SUBJECT: Arkansas Nuclear One - Unit 1
Docket No. 50-313
License No. DPR-51
Questions on the Emergency
Feedwater System Upgrade
Reliability Analysis

ADDITIONAL INFORMATION
CONCERNING
EMERGENCY FEEDWATER UPDRAGE RELIABILITY ANALYSIS
FOR
ARKANSAS NUCLEAR ONE, UNIT NO. 1
DOCKET NO. 50-313

RELIABILITY OF ANO-1 EFW SYSTEM

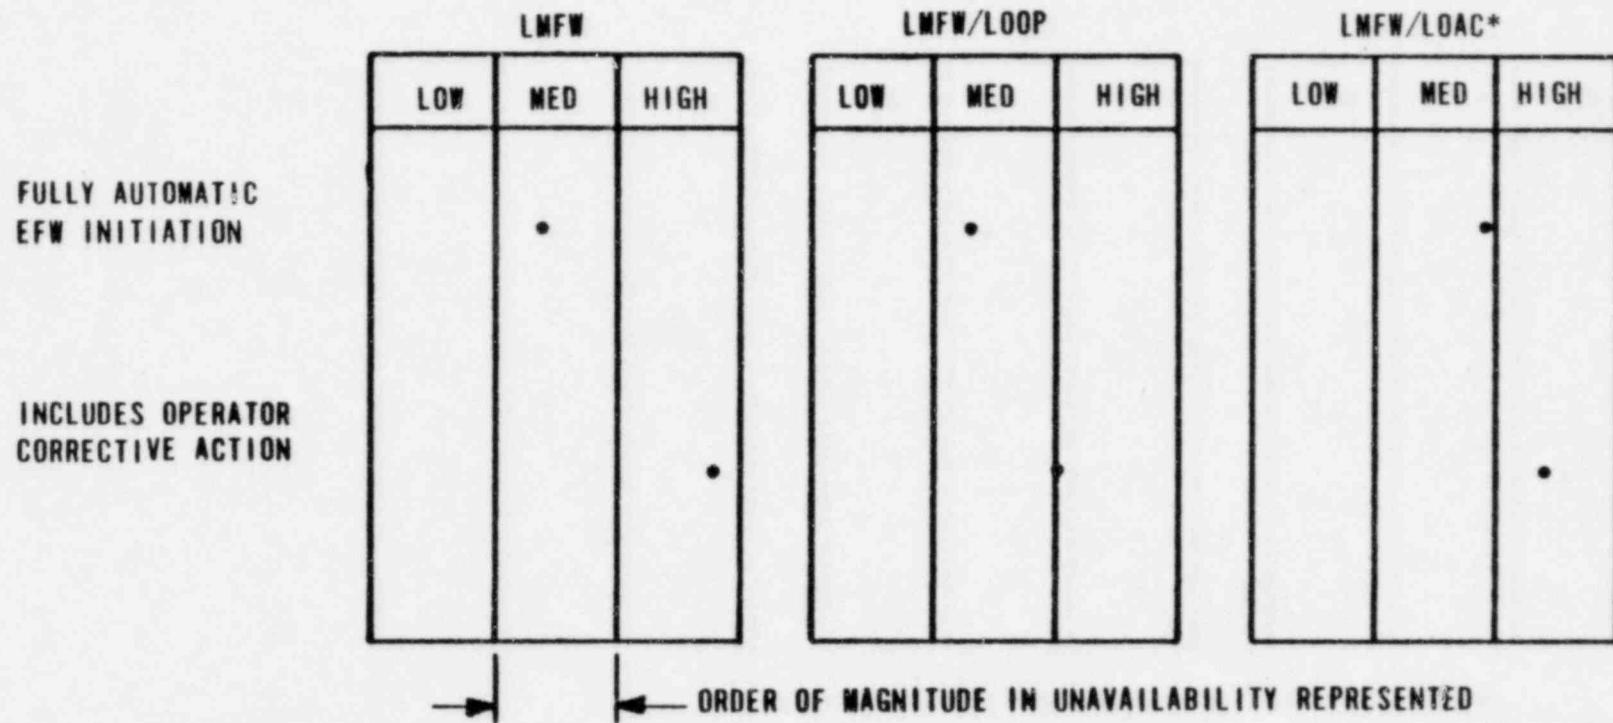
"The report's results are not presented in a manner that lends itself to a "NUREG-0611-type" comparison. For example, unavailability given LOOP is not tabulated. LOOP appears as a basic event on the fault tree; was this entered as the probability of LOOP given LMFW? How was this handled?"

The presentation of these results in the format of NUREG-0611 does not imply that comparisons to NUREG-0611 are appropriate. Because the scope and assumptions of the analysis are different than for the NUREG-0611 analysis; there is no common basis for comparison. For example, the assumptions used for power availability illustrate the differences. NUREG-0611 assumed perfect DC power (i.e., failure probability of 0.0) for all cases, and one of two perfect diesel generators for this LOOP case. The analysis of ANO-1 EFW reliability evaluated power reliability in detail and assumed realistic probabilities for DC power and diesel generator failure.

The attached figure 1.1 "Reliability of ANO-1 EFW System" supplies the results of the report "Emergency Feedwater System Upgrade Reliability Analysis for the Arkansas Nuclear One Nuclear Generating Station Unit No. 1, April 1981" in the format of NUREG-0611. The attached table (Figure 1.2) "Unavailabilities for ANO-1 EFW" supplies the numerical results broken down into the three cases; loss of main feedwater (LMFW), loss of offsite power (LOOP), and loss of AC power (LOAC).
